Well Name: EAGLE 34 E FEDERAL	Well Location: T17S / R27E / SEC 34 / SWNW /	County or Parish/State: EDDY / NM
Well Number: 53	Type of Well: OIL WELL	Allottee or Tribe Name:
Lease Number: NMLC067849	Unit or CA Name:	Unit or CA Number:
US Well Number: 300153346300S1	Well Status: Producing Oil Well	Operator: REDWOOD OPERATING LLC

Sundry ID: 2657692

Type of Action: Plug and Abandonment

OPERATOR NAME:	Redwood Operating, LLC
LEASE NO.:	NMLC067849
WELL NAME & NO.:	Eagle 34 E Federal #53
US WELL NUMBER:	30-015-33463
LOCATION:	T17S, R27E, Sec 34
COUNTY:	Eddy, NM

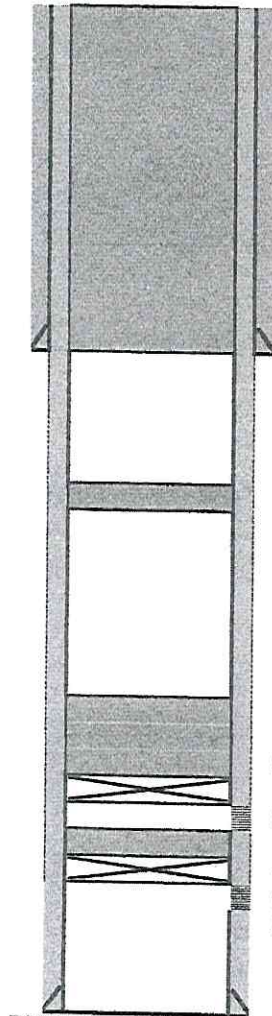
1. Set 5 1/2" CIBP @ 2852'. Spot 25 sx cmt @ 2852-2652'. WOC & Tag
2. Set 5 1/2" CIBP @ 1832'. Circ hole w/ MLF. Pressure test csg. Spot 65 sx cmt @ 1832-1216'. (Grbg, SA) 1823' to 1216'
3. Spot 25 sx cmt @ 957-757'. (Queen)
4. Spot 50 sx cmt @ 475' to surface. (8 5/8 Shoe & 7 Rivers)
5. Cut off well head, verify cmt @ surface, weld on Dry Hole Marker.

Plug Type	Top	Bottom	Length	Tag	Sacks	Notes
Surface Plug	0.00	475.00	475.00	Tag/Verify		
				If solid base no need to Tag (CIBP present and/or Mechanical Integrity Test), If Perf & Sqz then Tag, Leak Test all CIBP if no Open Perforatio		
Fresh Water @ 350	296.50	400.00	103.50			
Shoe Plug	370.75	475.00	104.25	Tag/Verify	50.00	Spot from 475' to surface. Verify at Surface.
San Andres @ 1545	1479.55	1595.00	115.45	If solid		
				If solid base no need to Tag (CIBP present and/or Mechanical Integrity Test), If Perf & Sqz then Tag, Leak Test all CIBP if no Open Perforatio		
CIBP Plug	1788.00	1823.00	35.00	Perforatio	65.00	Set CIBP at 1823'. Spot from 1823' to 1216'. Leak Test CIBP.
Perforations Plug (If No CIBP)	1823.00	2296.00	473.00	Tag/Verify
